RE: CASE #13-242SP - Approval of a Site Plan for a Multi-Family Development, Being Fewer than 2 Acres, Located on the Northeast Corner of Chestnut Street and Walker Street

On February 25, 2014, the Planning and Zoning Commission approved the site plan for a multi-family development, which was received by the Planning Department on February 17, 2014. The approval is conditioned as follows:

01 ARCHITECTURAL SITE PLAN
 SCALE 1"=20'-0"

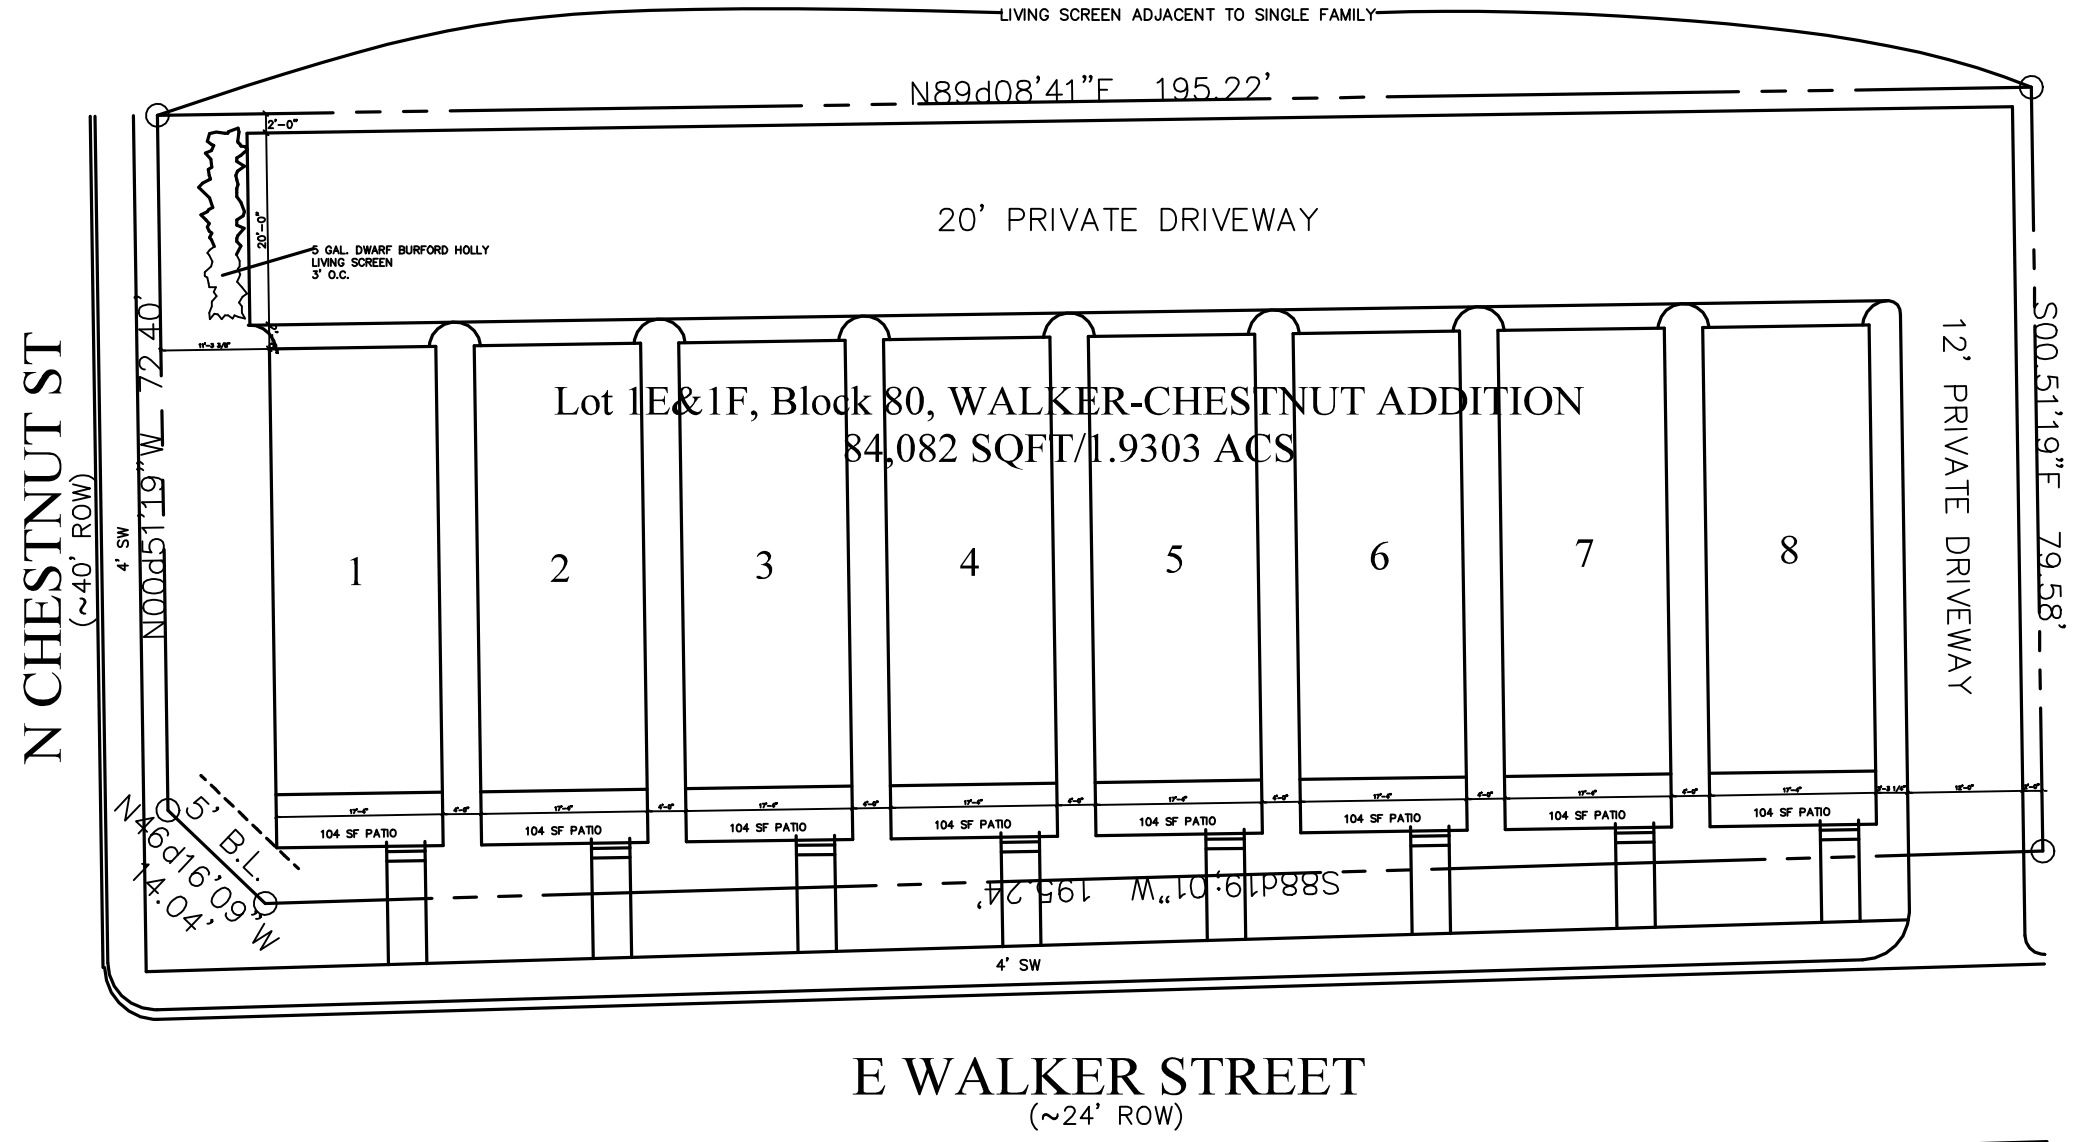
3. The applicant revise the site and landscape plan to show a minimum 5' radius on both sides of the private drive at the Walker Street connection.
4. The applicant revise the elevations to remove the "painted brick" callouts for the brick columns.
5. The applicant revise the site and landscape plan to reference the lot as Lot 1, Block A of the Walker-Chestnut Addition.
